May 5, 2021

Re: Application for Comprehensive Permit – 91 Beatrice Circle, Belmont

Figure 1

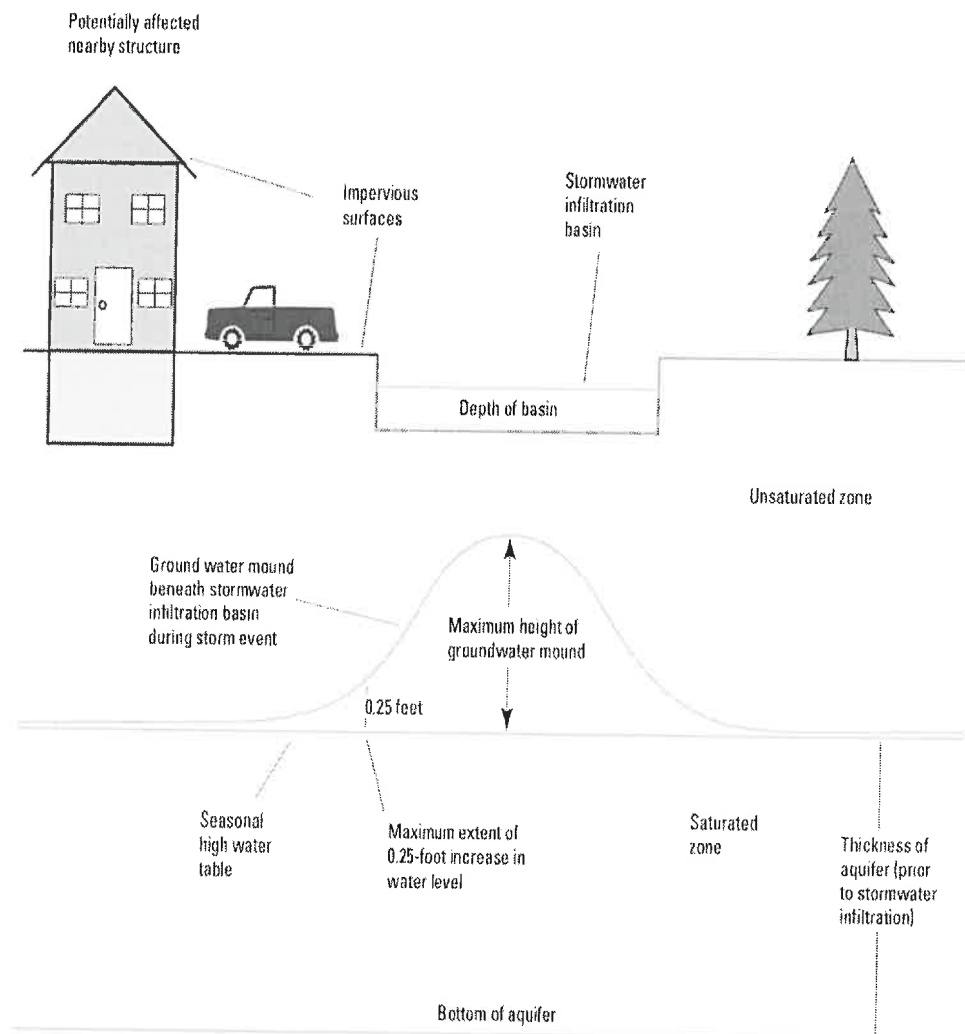
(b) Mounding Analysis Errors. W&S appropriately criticized the Applicant for not initially providing a "mounding analysis" for the large, subsurface stormwater infiltration system which serves to collect most of the runoff generated on the Site. A mounding analysis is necessary to accurately predict the runoff storage capacity of infiltration chambers during

extreme storm events. If these chambers are not sized properly, flooding of downgradient properties and Frontage Road will occur. The graphic below (**Figure 1**), reproduced from a USGS publication, illustrates the groundwater mounding effect from infiltration systems. If the mound rises to an elevation that is *higher* than the bottom of the chamber, the chamber loses its storage capacity.

W&S correctly noted in its current letter (p. 5) that Mr. Burke applied incorrect variable assumptions in his mounding analysis, which has the effect of underestimating the mounding effect, and thus underestimating the risk of failure of this critical drainage facility.
